FINAL ENVIRONMENTAL IMPACT STATEMENT

Letchworth Road Residential Development

**LETCHWORTH ROAD
TOWN OF HAVERSTRAW
ROCKLAND COUNTY, NY**

III. RESPONSE TO COMMENTS	III-1
A. Introduction	III-1
B. Comment Key	III-1
III.C.1A Comments Regarding DEIS Executive Summary	III.C.1A-1
III.C.1B Comments Regarding DEIS Project Description	III.C.1B-1
III.C.2 Land Use and Zoning	III.C.2-1
III.C.3 Visual Resources and Community Character	III.C.3-1
III.C.4 Soils, Topography and Steep Slopes	III.C.4-1
III.C.5 Flora and Fauna	III.C.5-1
III.C.6 Stormwater Management	III.C.6-1
III.C.7 Water Supply and Sanitary Sewerage	III.C.7-1
III.C.8 Other Utilities and Services	III.C.8-1
III.C.9 Traffic Transportation and Parking	III.C.9-1
III.C.10 Community Demographics, Facilities and Services	III.C.10-1
III.C.11 Fiscal and Economic Conditions	III.C.11-1
III.C.12 Noise and Air Quality	III.C.12-1
III.C.13 Historic and Cultural Resources	III.C.13-1
III.C.14 Construction	III.C.14-1
III.C.15 Significant Adverse Environmental Impacts that Cannot be Avoided	III.C.15-1
III.C.16 Alternatives	III.C.16-1

FIGURE: 01

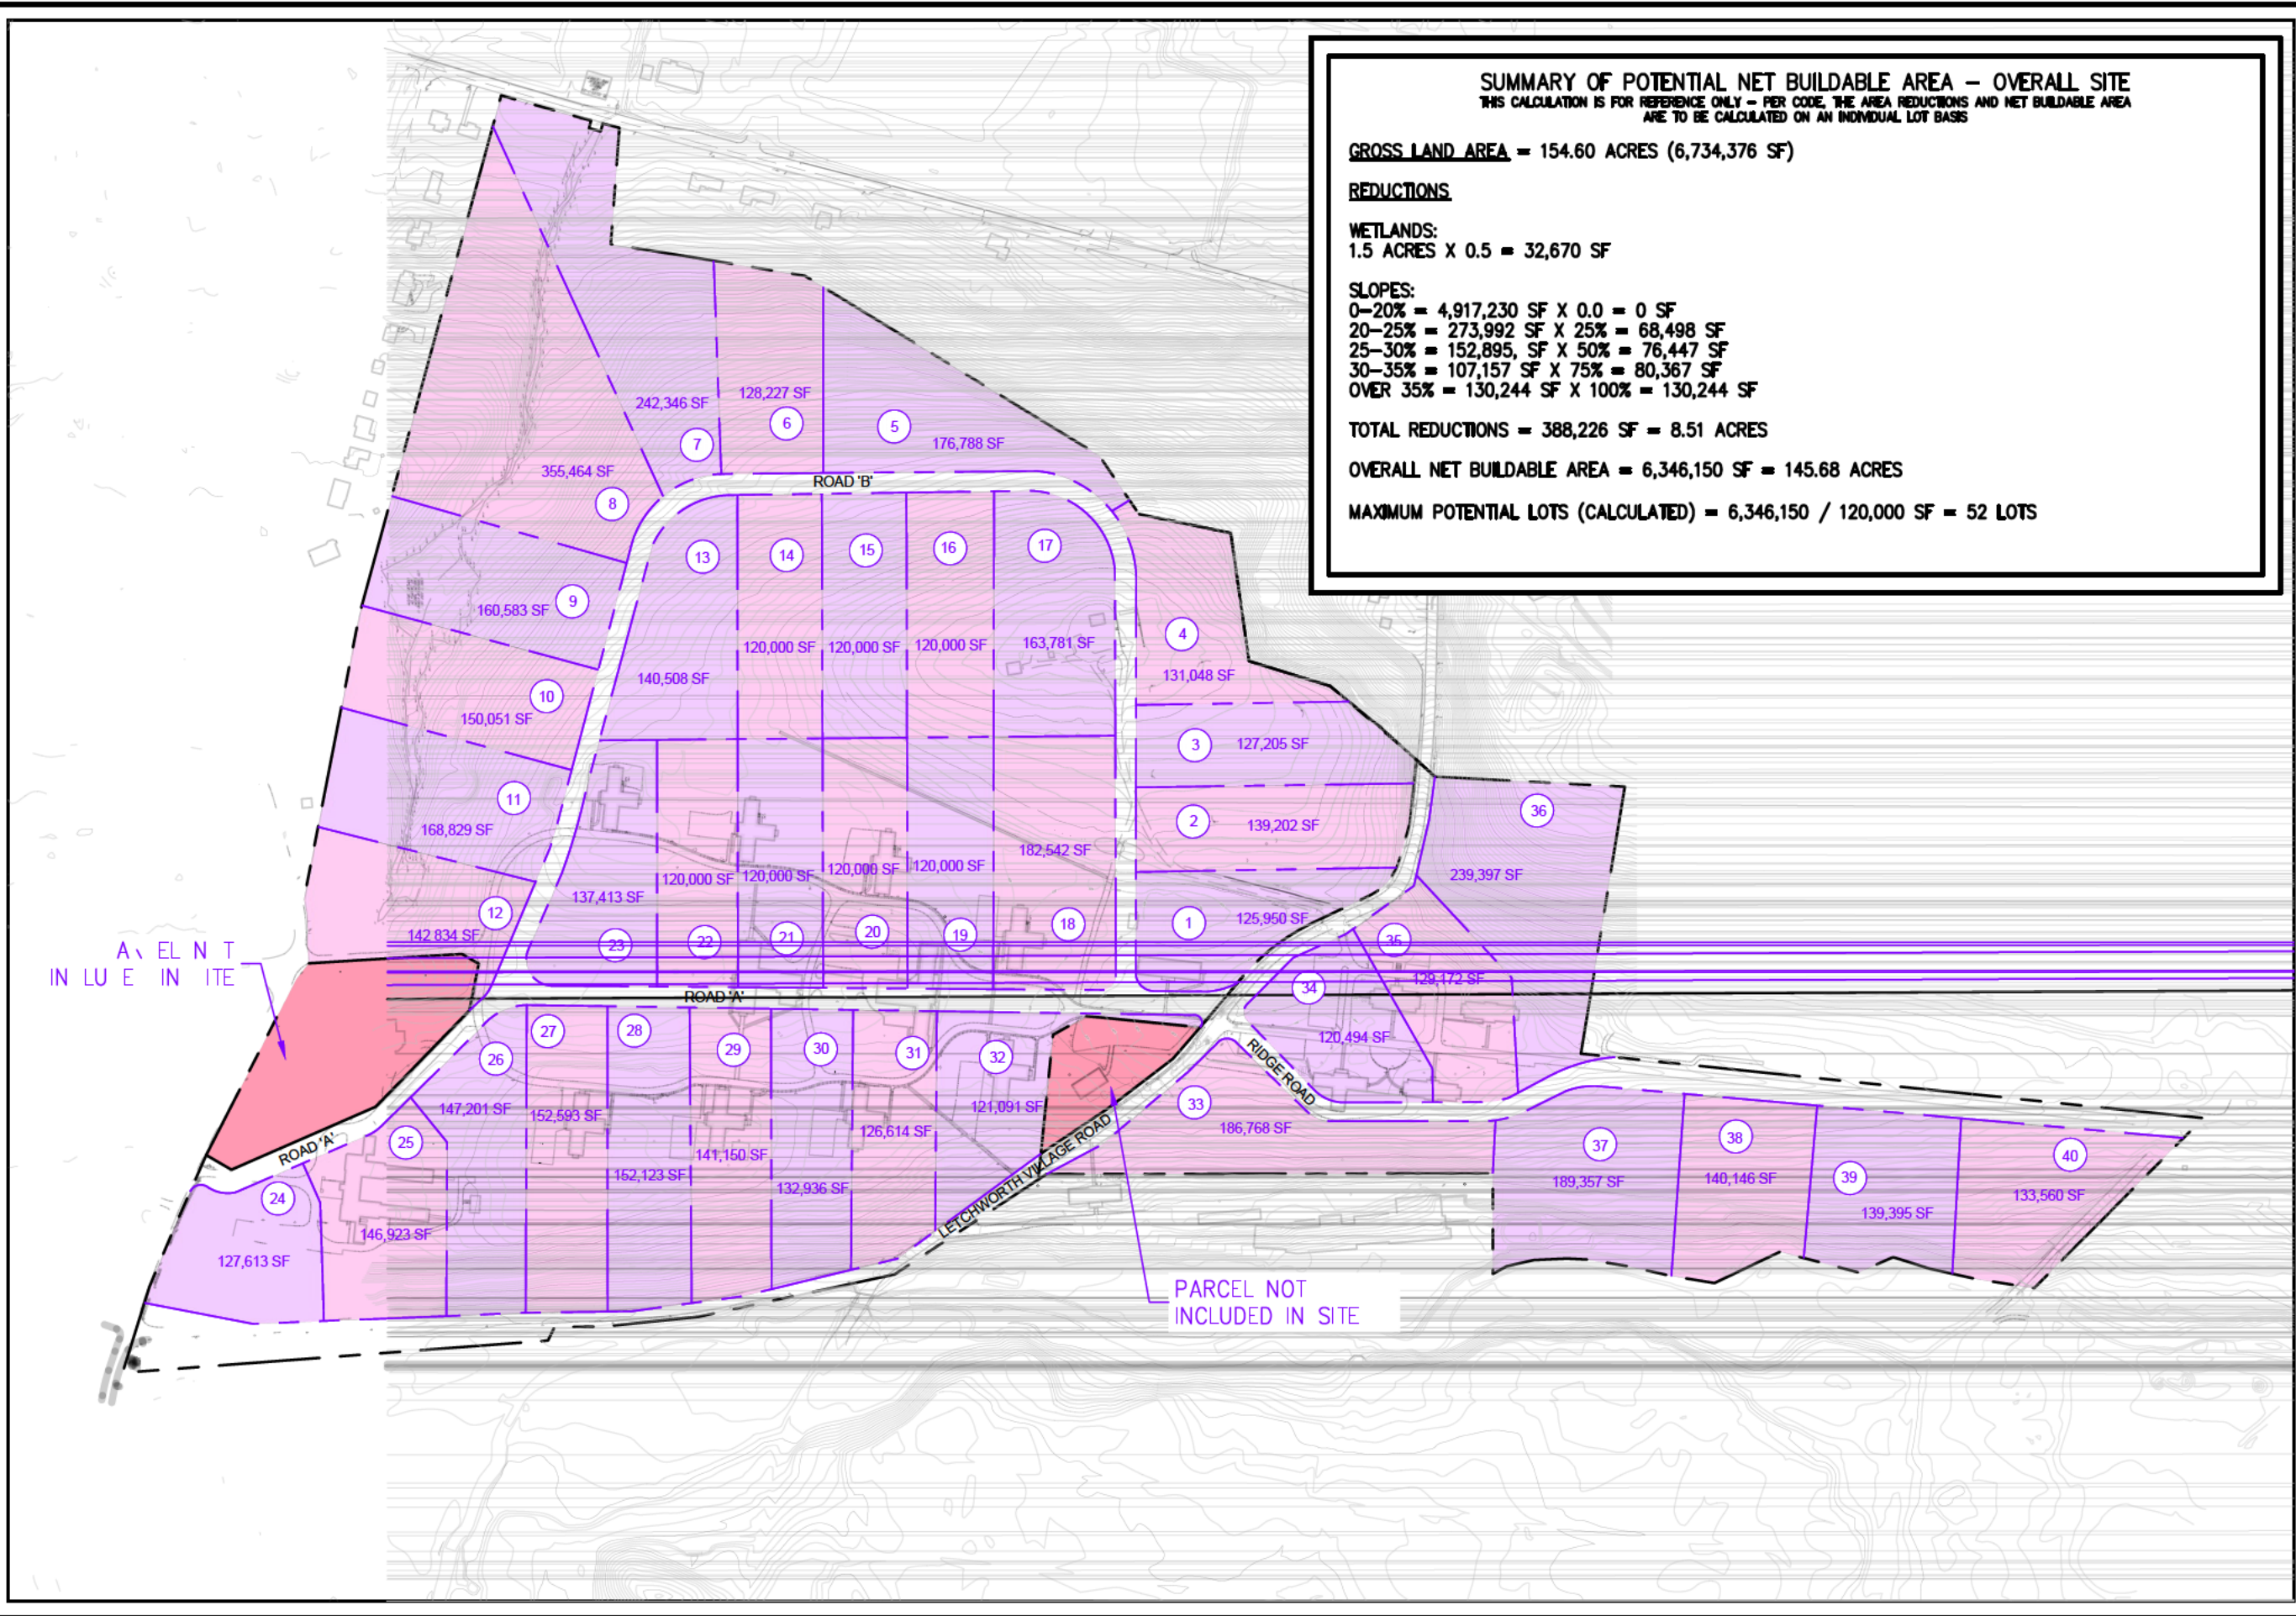
Comment No. 2-5

Based on discussions with the Town, we have prepared a conceptual subdivision sketch showing how a development within the R-120 Zone would look for the entire ±154.5 acre property, which is included as Figure 01.

FIGURE: 02

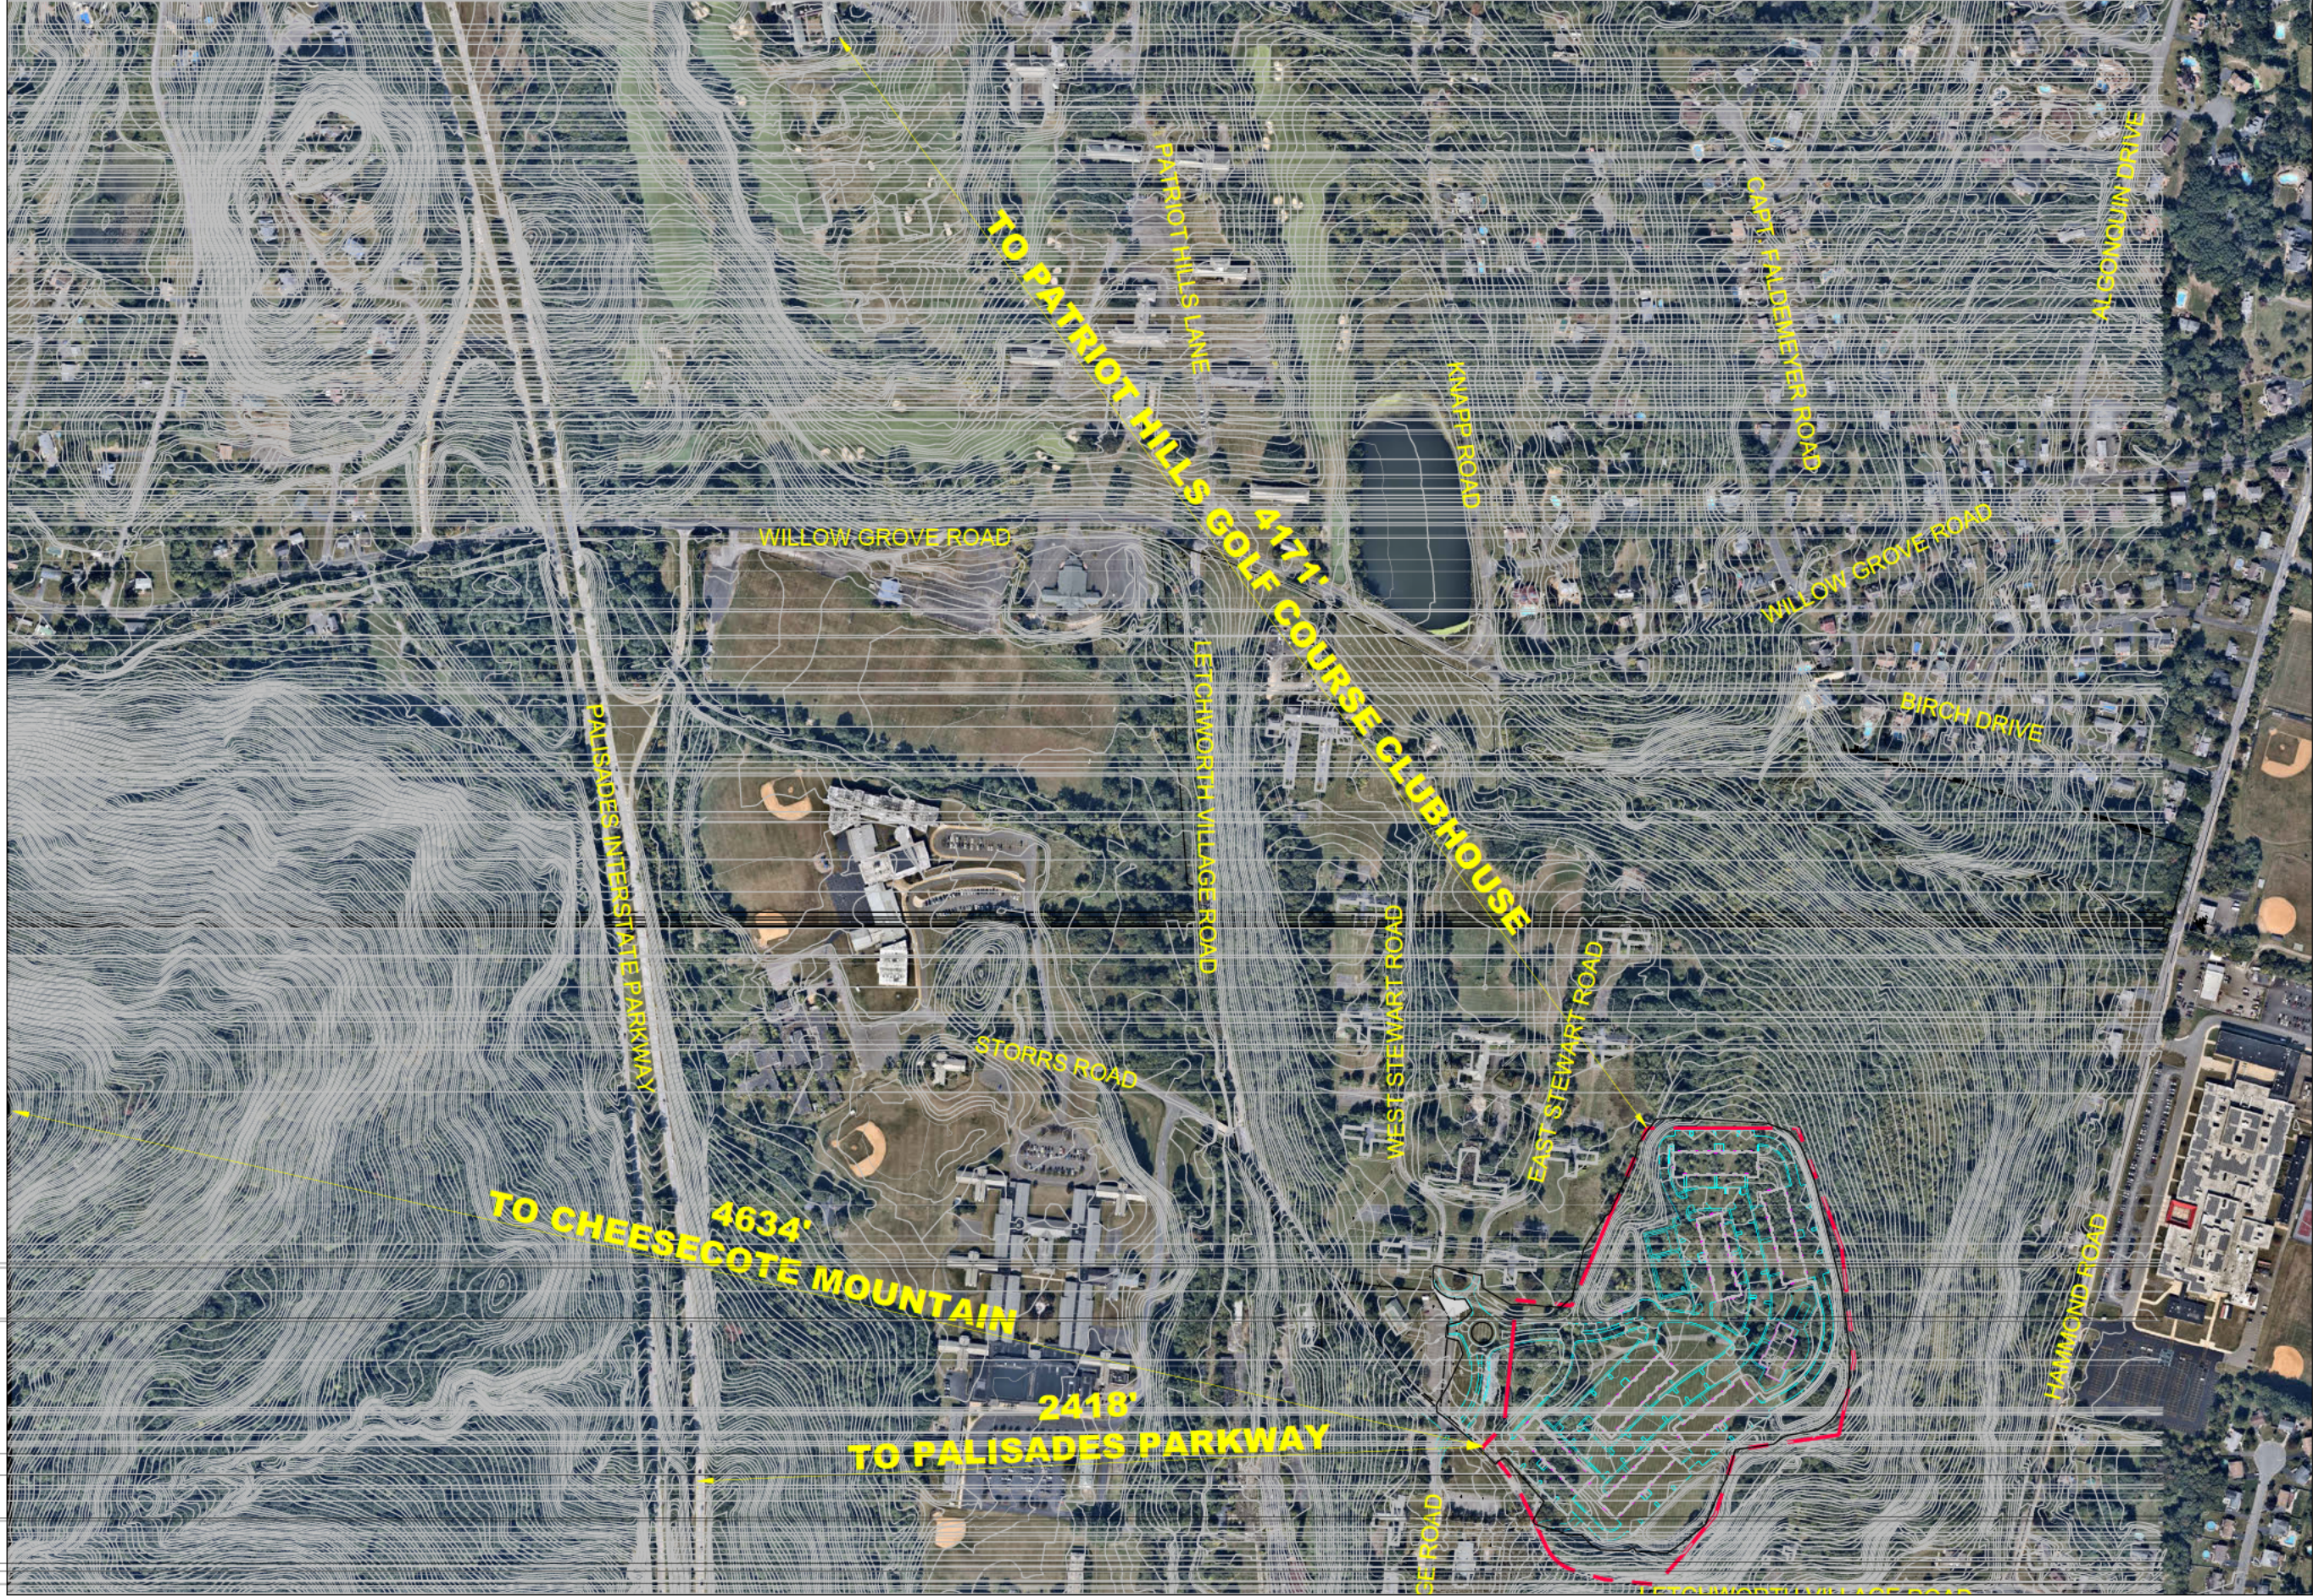
Comment No. 3-1

Figure No 02 has been prepared demonstrating that the project will not be visible from the broader regional viewpoints considering the distance, topography, and vegetation between the project site and surrounding areas.
